**Attachment 1 –
Revised Drainage Impact Assessment**

Drainage Impact Assessment

Report Reference: 240010.03

**Proposed Residential Development at
Various Lots in DD385, Tai Lam Chung, Tuen Mun
Response to Comments on Drainage Impact Assessment (DIA) Report**

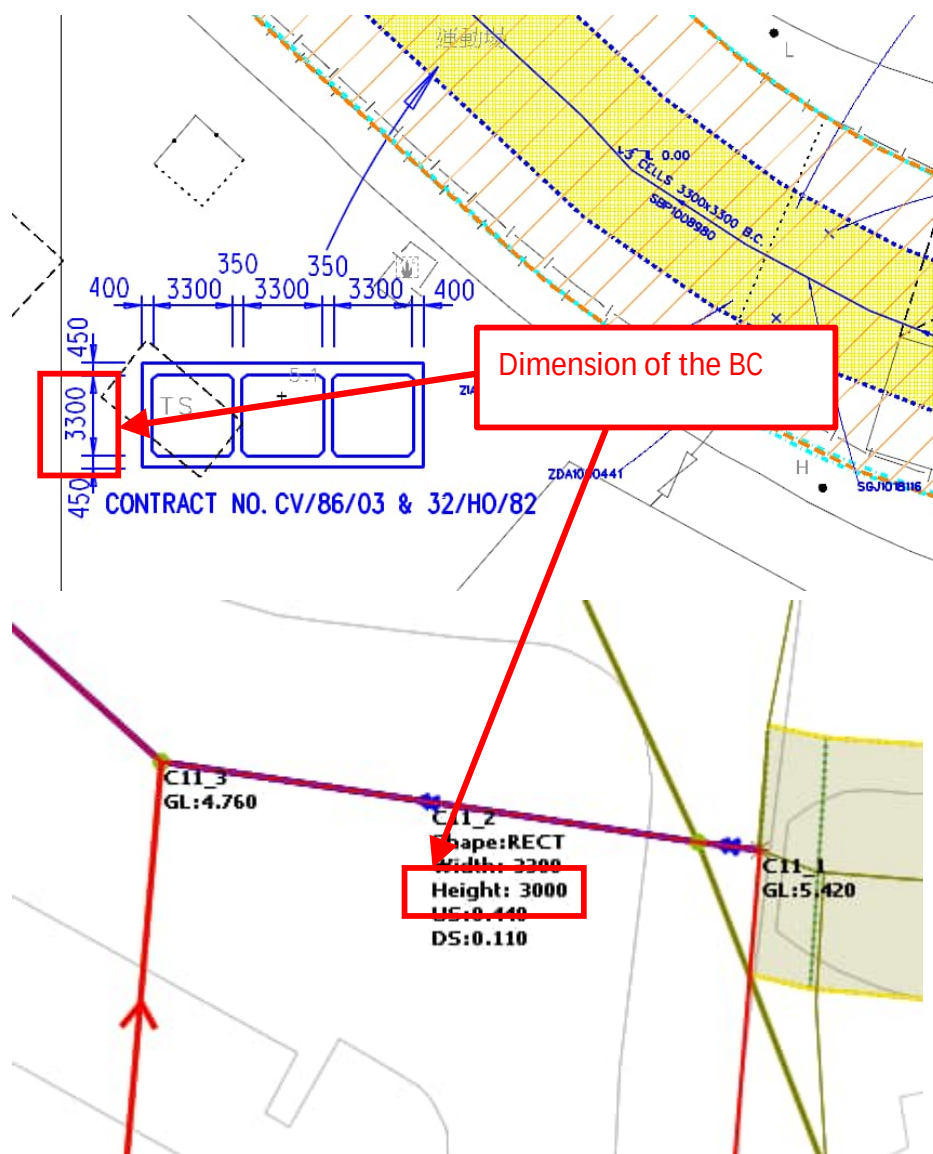
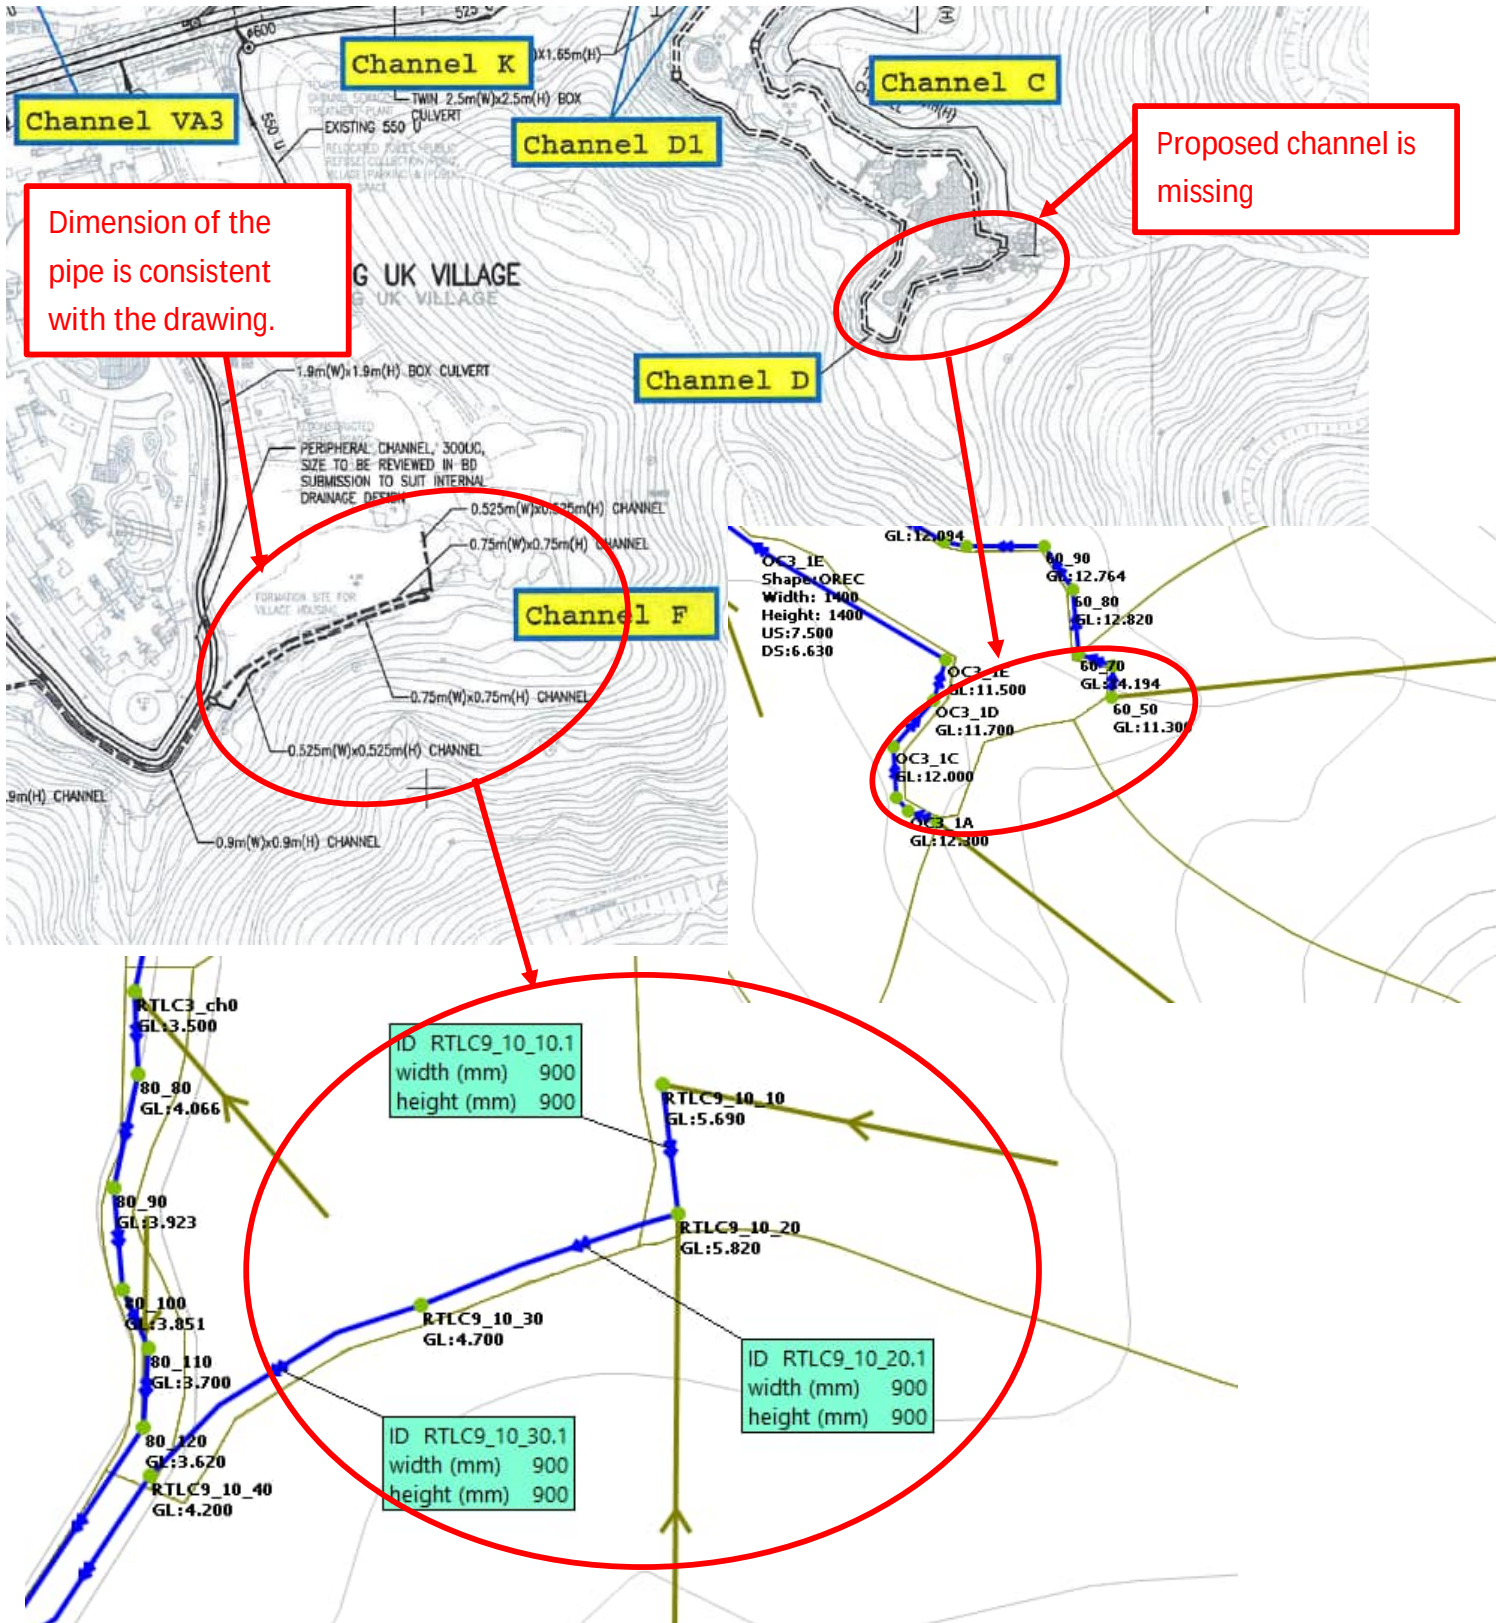
4. Drainage network is inconsistent with our drainage record and the drainage arrangement. Please review.

(3)	Value of catchment B2 and U1 in Table 1 are duplicated. Please clarify	Table 1 is revised.
(4)	Drainage network is inconsistent with our drainage record and the drainage arrangement. Please review.	The hydraulic model is revised accordingly.

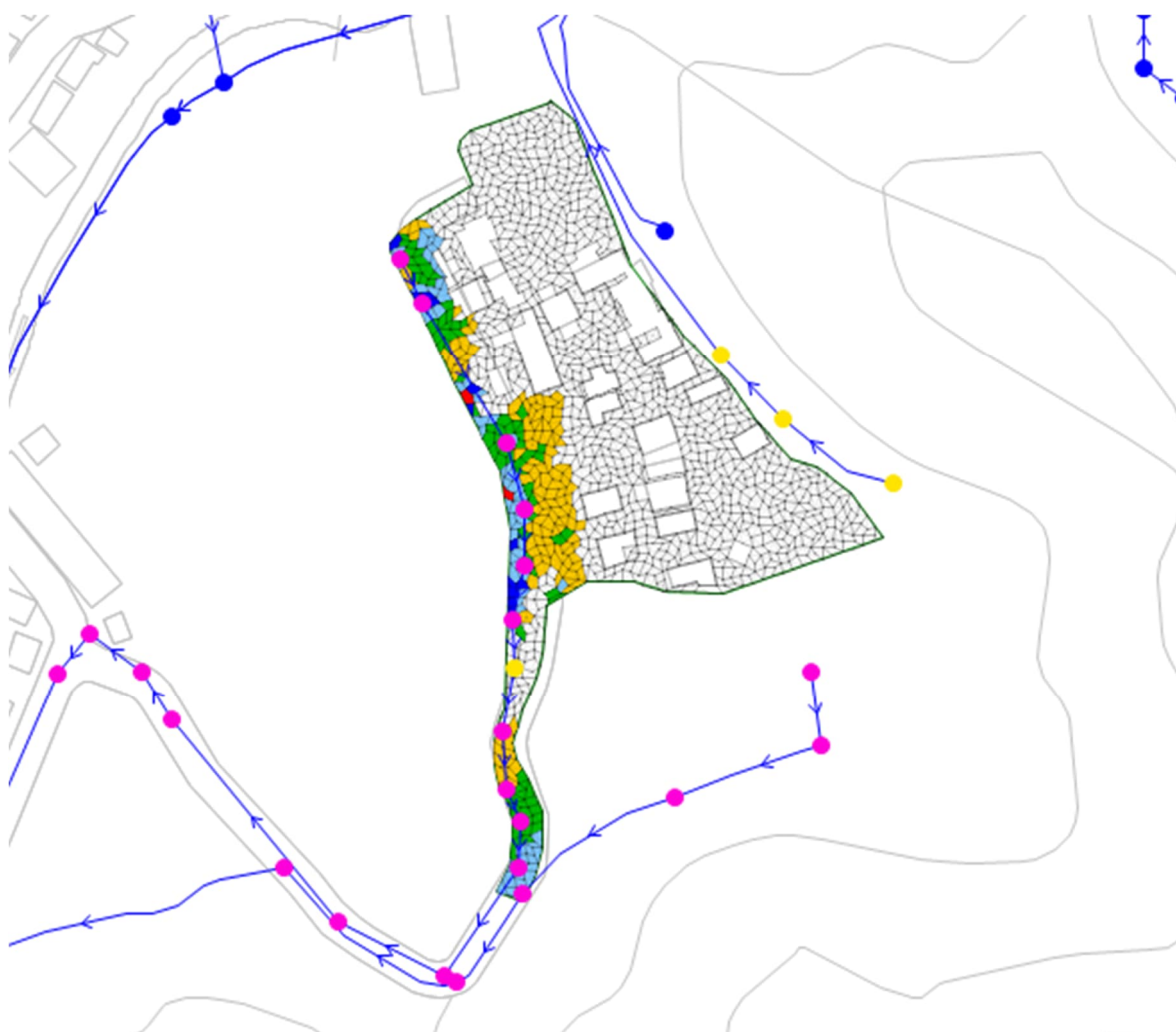
6. Flap gate, pumps and flood walls is not incorporated in the model. Please clarify.
7. The drainage performance of the proposed network may be less than 2year return period. Sample as below. Please review.

(6)	Flap gate, pumps and flood walls is not incorporated in the model. Please clarify.	Dredging with 600mm silt depth in the Tai Lam Chung Tributary is incorporated in the model according to para. 5.2.4.

(7)	The drainage performance of the proposed network may be less than 2year return period. Proposed Drain between nodes 70_50 & 70_80 and 80_50 & 80_70. Please review.	Please be advised that the ground level is below the latest 50-yr sea level with consideration mean sea level rise and storm surge increase due to Climate Change in Mid 21st Century. Nevertheless, the maximum water levels in Wong Uk Village and other low lying areas are reduced after the development and proposed drainage works.
